CITY OF ALBUQUERQUE

June 25, 2024

Re: Honeywell
9201 Pan American Fwy NE
Conceptual Traffic Circulation Layout for DFT Approval
Engineer's Stamp 06-21-24 (B17-D001B)

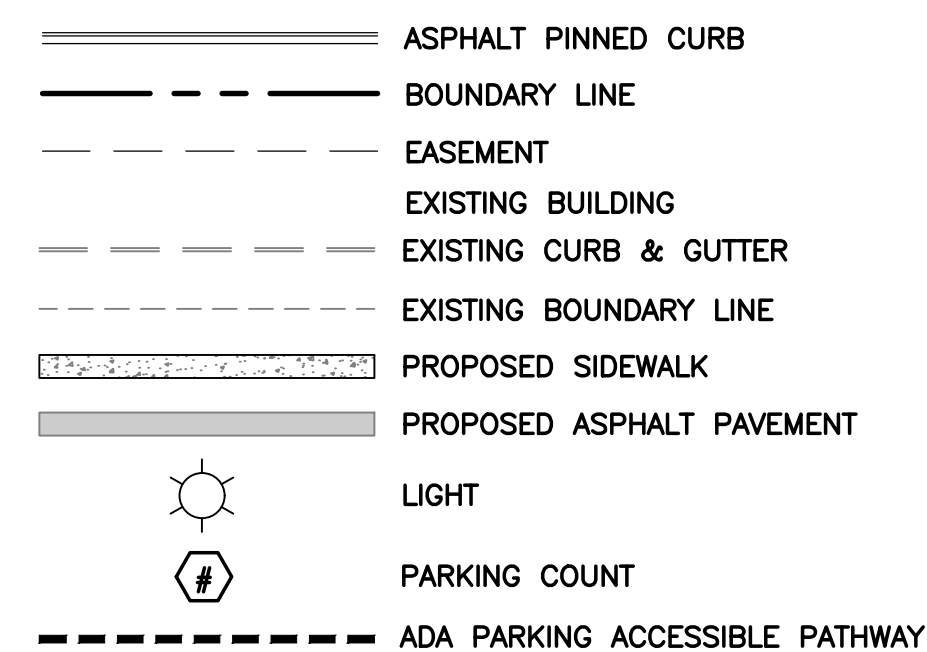
1. ADA ACCESSIBLE PEDESTRIAN PATHWAY SHOULD NOT BE PLACED BEHIND PARKING SPACES OR ADJACENT TO A VEHICLE WAY.
2. IT IS ACCEPTABLE TO KEEP EXISTING WAVE-STYLE BIKE RACK, BUT ALL NEW RACKS MUST COMPLY WITH THE DPM.
